Sedgwick County
EMS Post 15
3575 N. Webb Road
Wichita, Kansas
RFB#: 18-0023

Addendum No. 2
March 30, 2018
KA # 17045

SPECIFICATIONS AND DRAWINGS

SHEET NO.
SA1.1

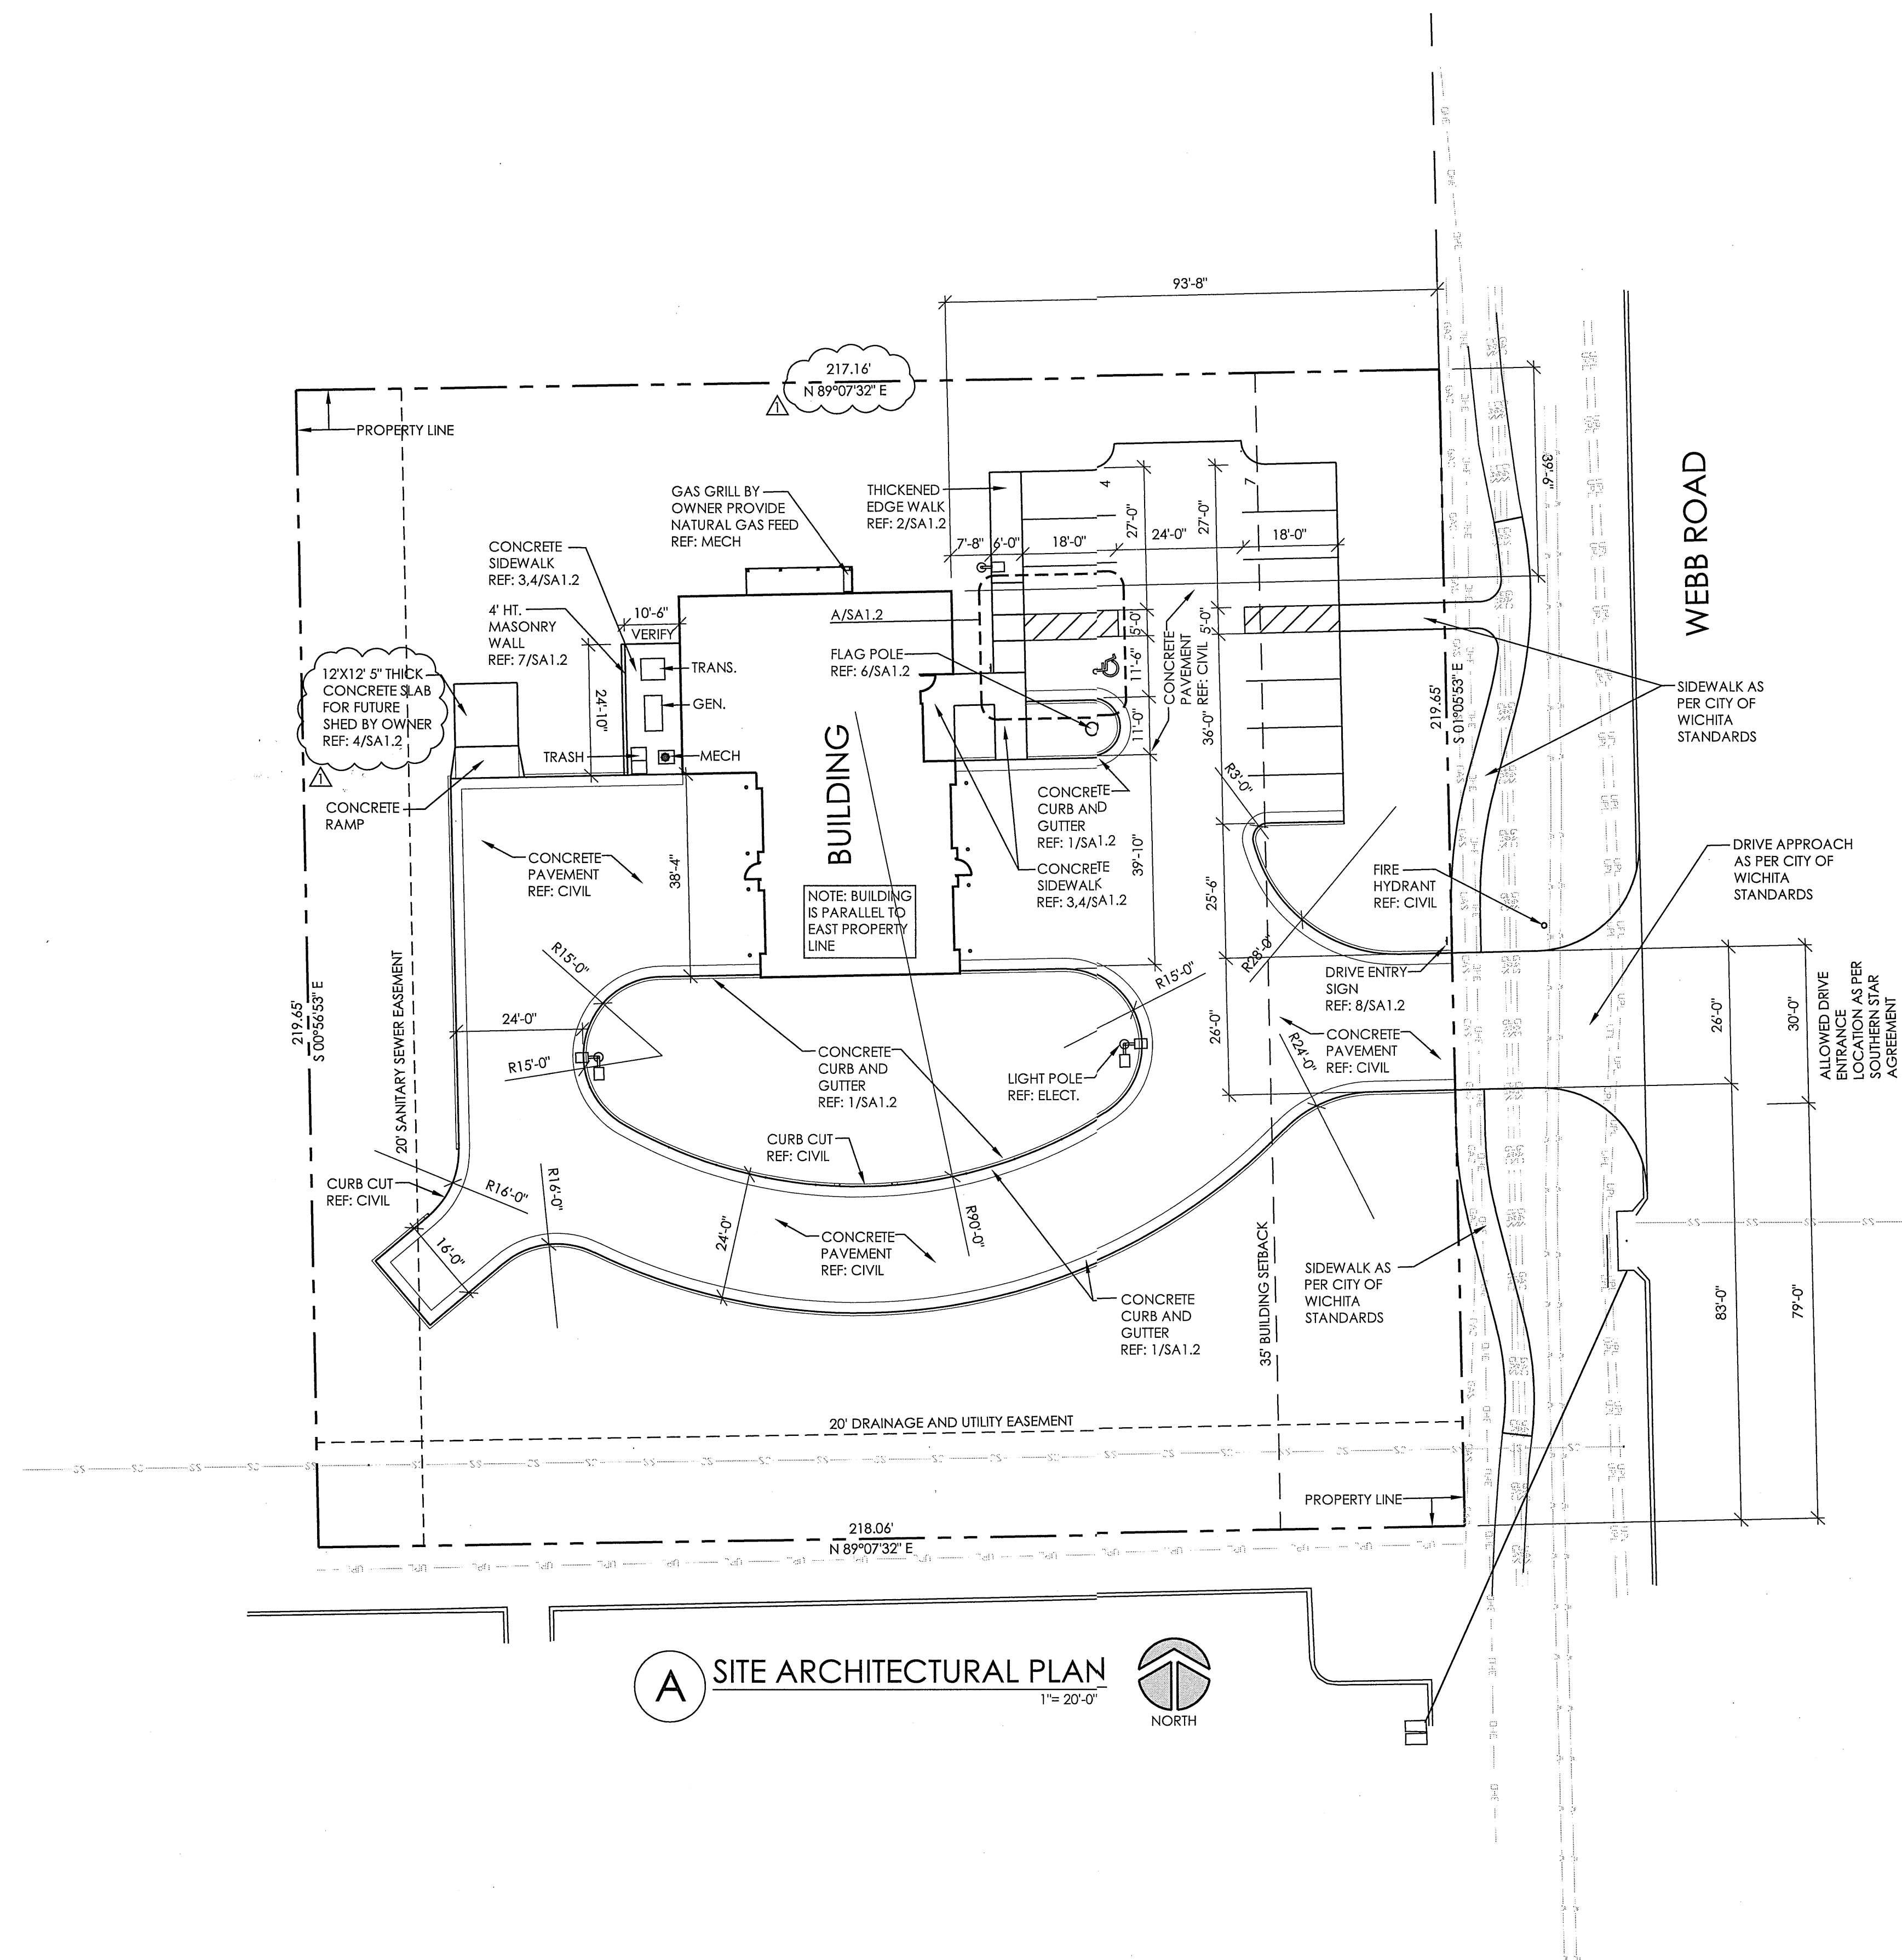
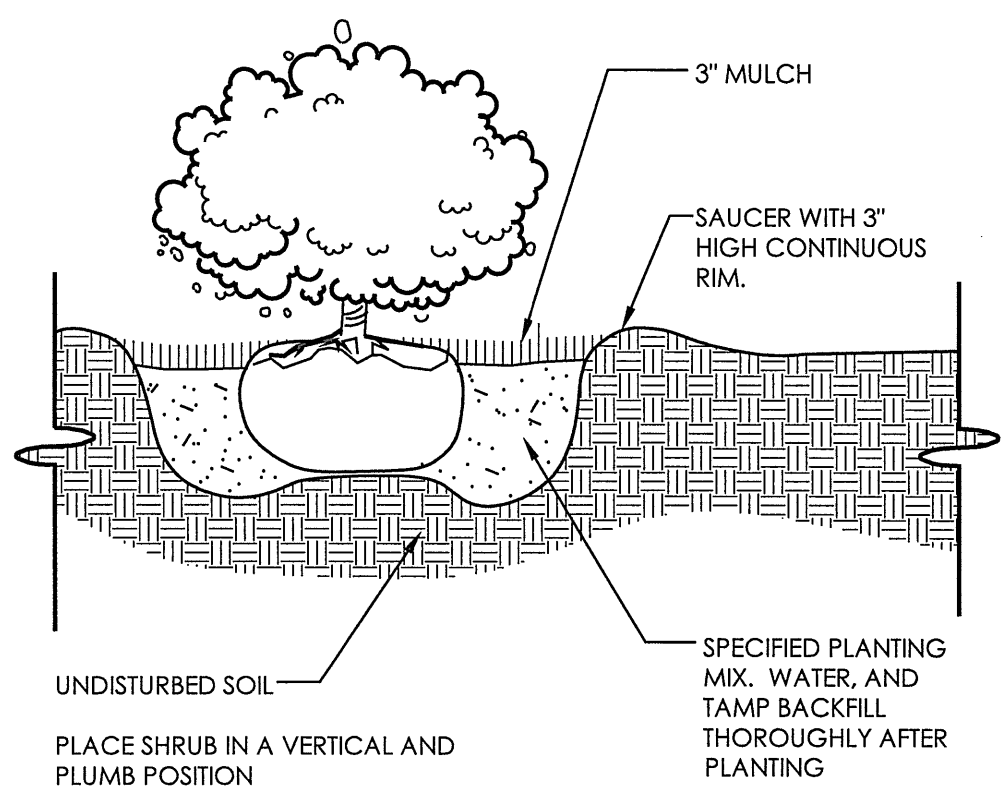
- A. Contractor to provide temporary irrigation for sod and shrubs. Water for temporary irrigation may come from hose bibs on building if available at time of planting. If water from building is unavailable contractor is to provide water from offsite. Sod is to be watered immediately after installation to a point where soil below is saturated to a depth of 2”. Keep soil beneath sod saturated for a period of 21 days then provide 1” of water per square foot once a week until substantial completion. Shrubs are to receive 1” of water per week at a minimum after planting until substantial completion. Ref. Revised Sheet SA1.1.

SHEET TITLE
Utility Plan

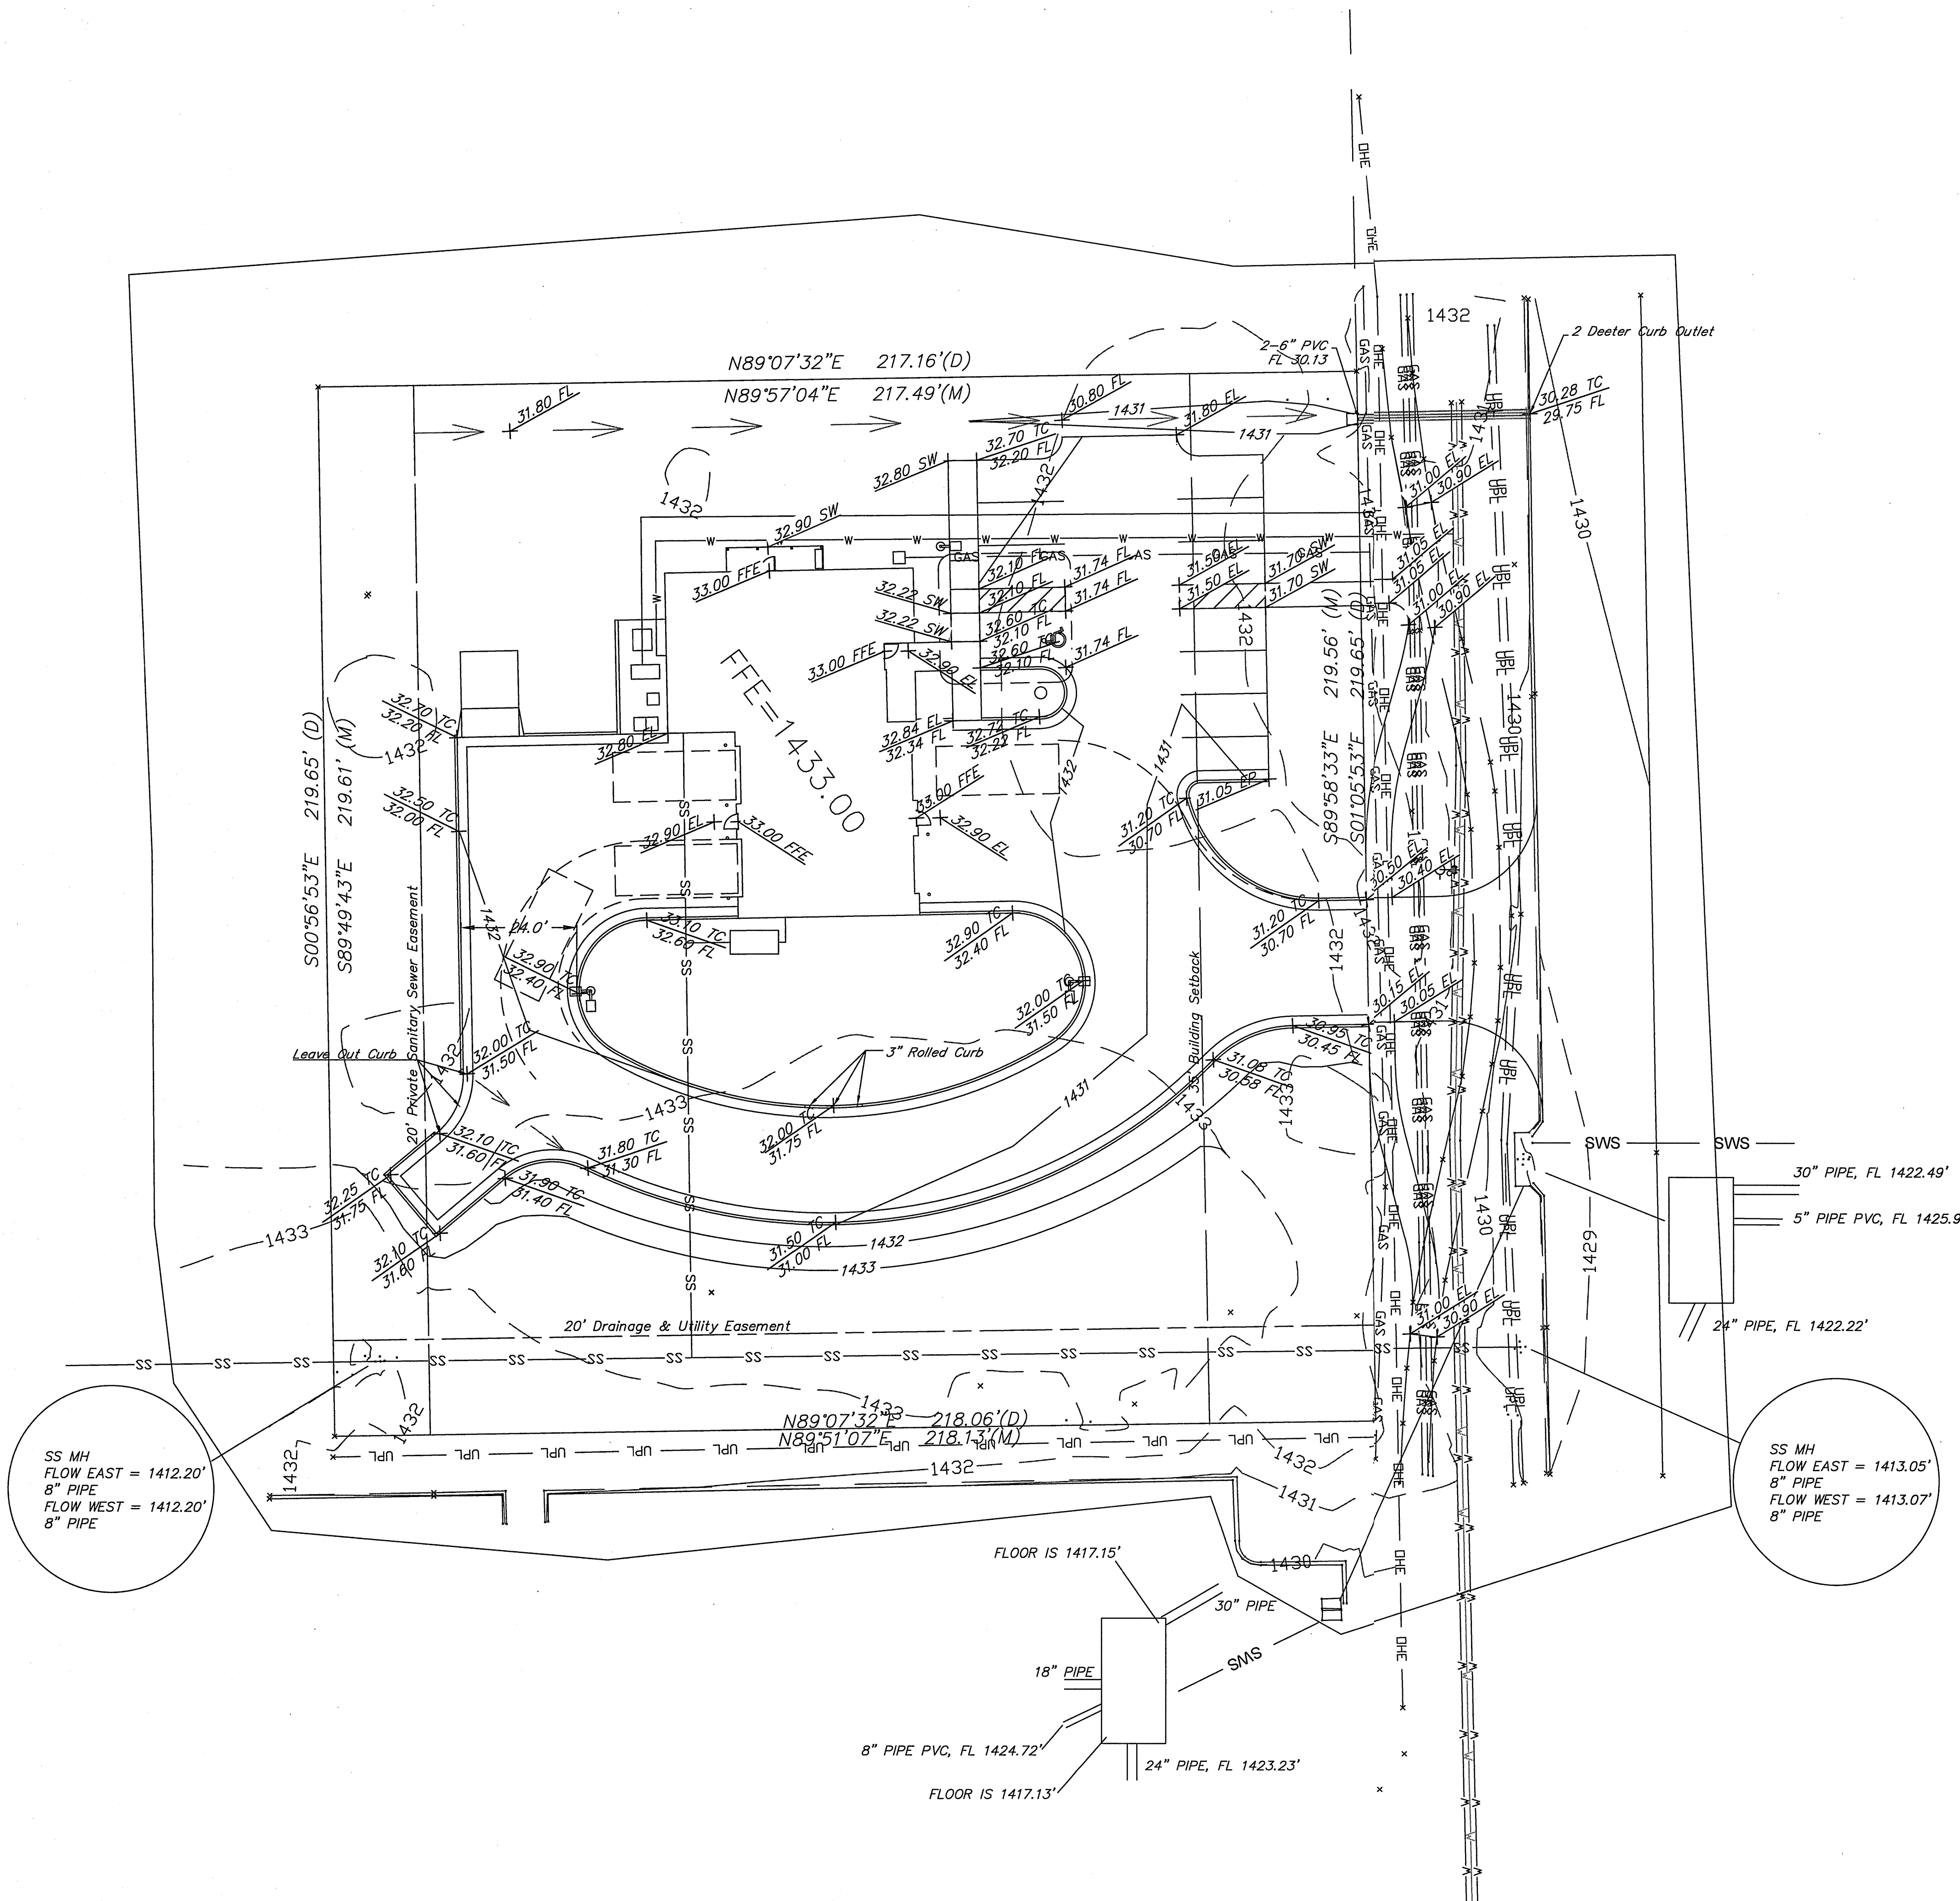
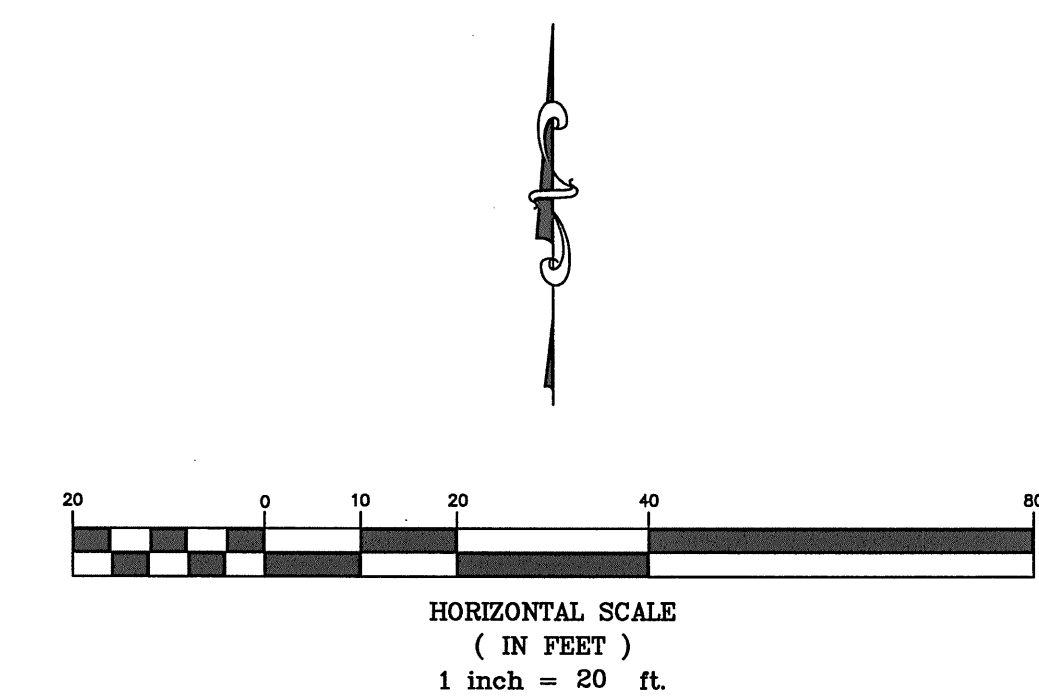
- A. Domestic Water Line Service shown on Civil Drawing Sheet C3.0 reads *Proposed 1194 LF 2" WL Service*. This is incorrect and should actually read *Proposed 194 LF 2" WL Service*. Ref. revised civil drawings.

16 EXT. WINDOW HEAD DETAIL 3'-1'-0"

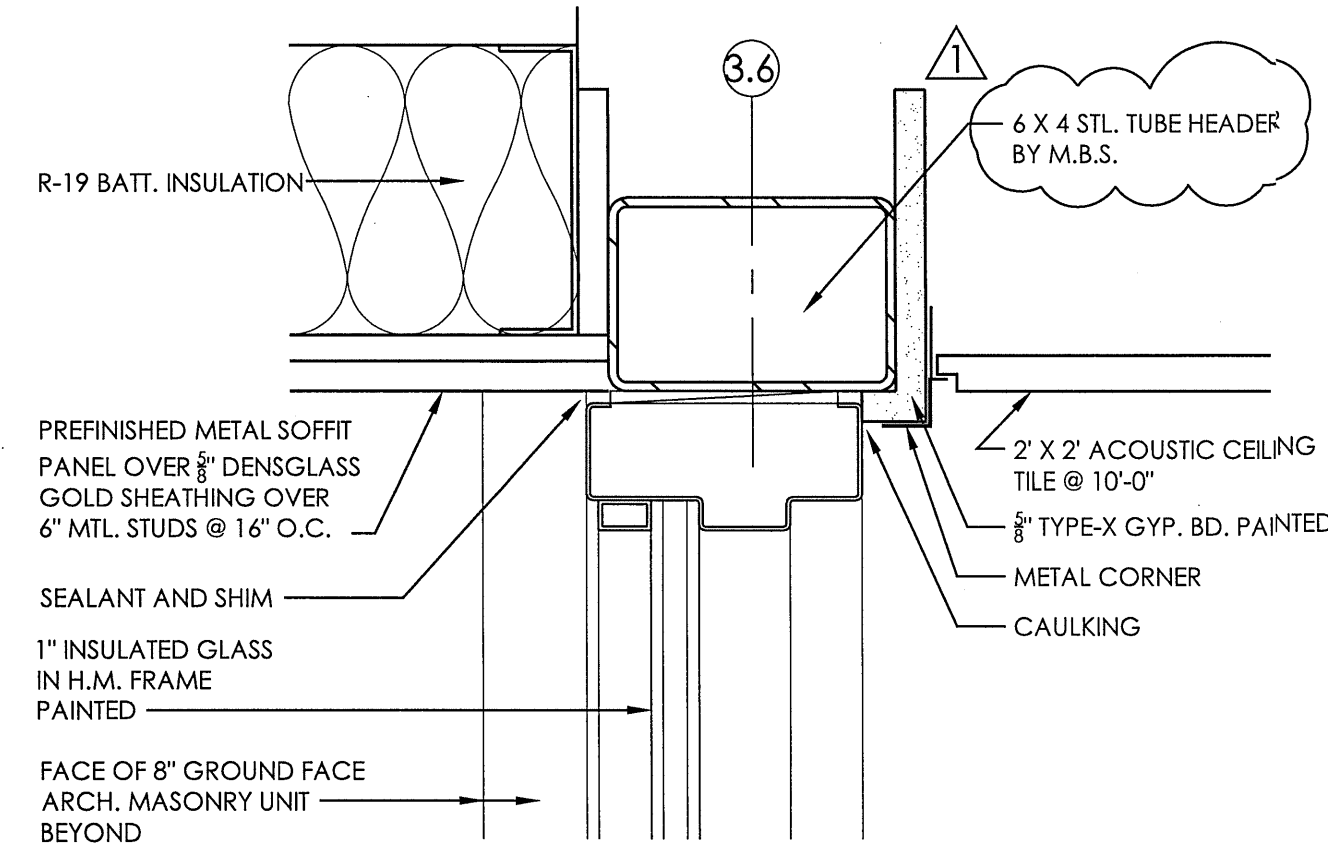
- E. Lintel above building entry door mark 1 and sidelight is to be a 6x4x1/4 steel tube in lieu of the metal stud box header indicated. Lintel to be supported on the north end by a 4x4x1/4 steel tube column and on a steel support angle off of the masonry wall on the south end. Ref. Revised sheets S1.1, A1.1, and details 16/A1.4, B/A3.1.
